ARCHITECTURAL REVIEW BOARD

LOCATION: Southeast corner 17th & K Street

PROPOSAL: New construction, office building over parking

Job No. 07101
 Scale 1/8" = 10'
 Ref. North 
 Sheet Title
SEVENTEENTH & K STREET
SITE PLAN & FIRST FLOOR
 Sheet No.

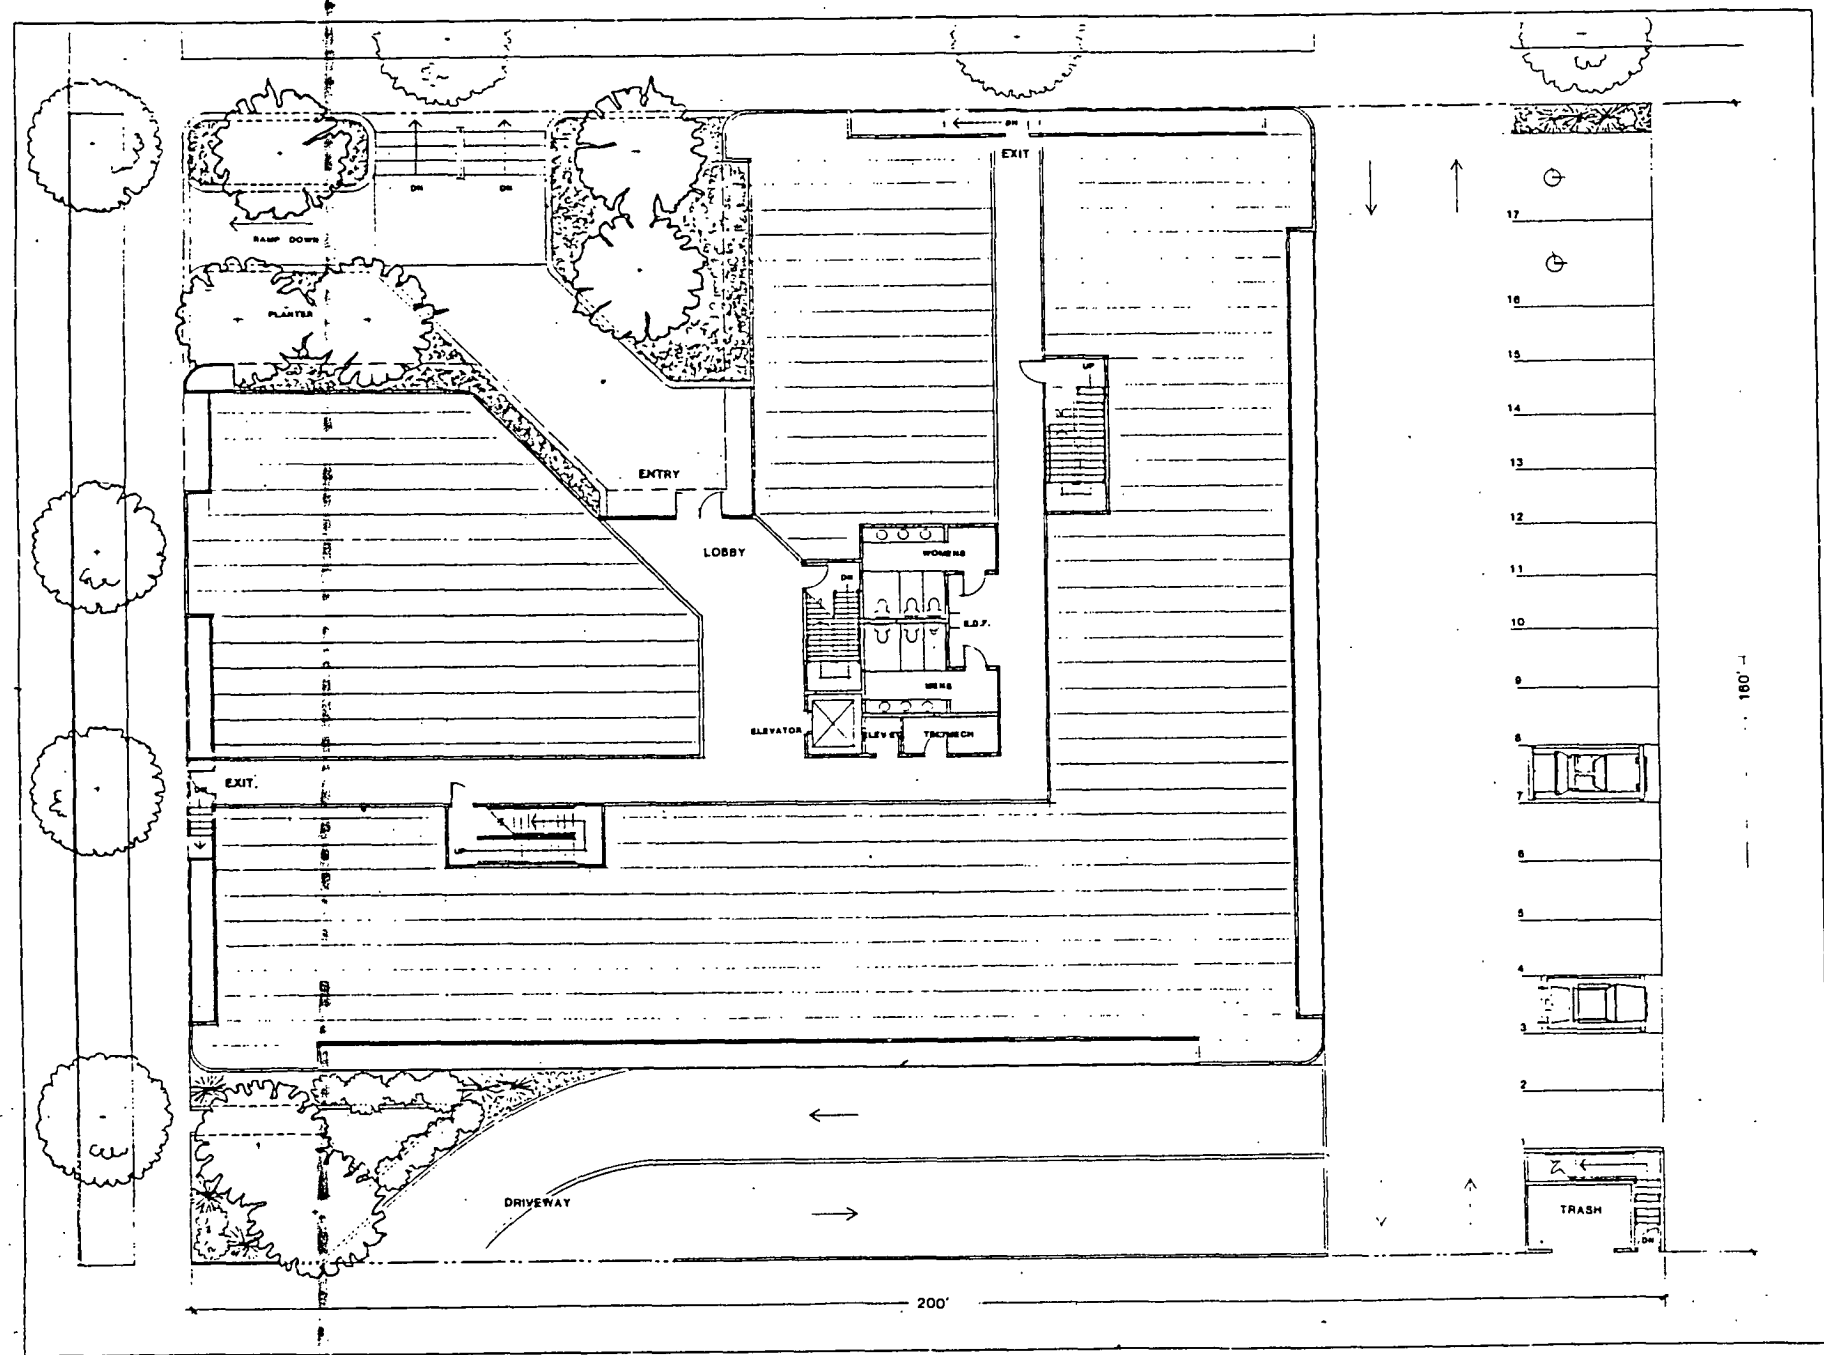
1. The number of parking spaces provided exceed the number required by one. The 17 spaces at ground level, to the east of the building, have no landscaping except at "O" Street. Staff feels that one space could be removed and two 4-foot wide planting areas provided. These planters could be spaced evenly between "O" Street and the alley.

2. Short-term use bike parking is needed on site. This could be provided at the east side of the front entry.
3. The Traffic Engineering Division has concerns with the entry - exit ramps to the basement parking area.

- a. No more than a 4 percent slope is allowed within the first 20 behind a property line adjacent to a street or alley. On the alley entrance this would be from the end of the brick wall, east 20 feet.

- b. The exit ramp should not exit to the alley but should exit to 17th Street.
 - c. A truck-loading area on the alley is needed. The loading area must have access to the elevator.

1. One parking space to be removed and two 4-foot wide planters to be provided, spaced evenly between "O" Street and the alley.
2. Class III bicycle parking to be provided at the east side of the front entry.
3. Entry - exit ramping to meet Traffic Engineering Division requirements.
4. Truck loading area to be provided ~~at alley~~ to meet Traffic Engineering Division requirements.
5. Final landscaping and irrigation plan to be returned to staff for review and approval.
6. Lot line adjustment to be approved by City Planning Commission before Building Permit is issued.
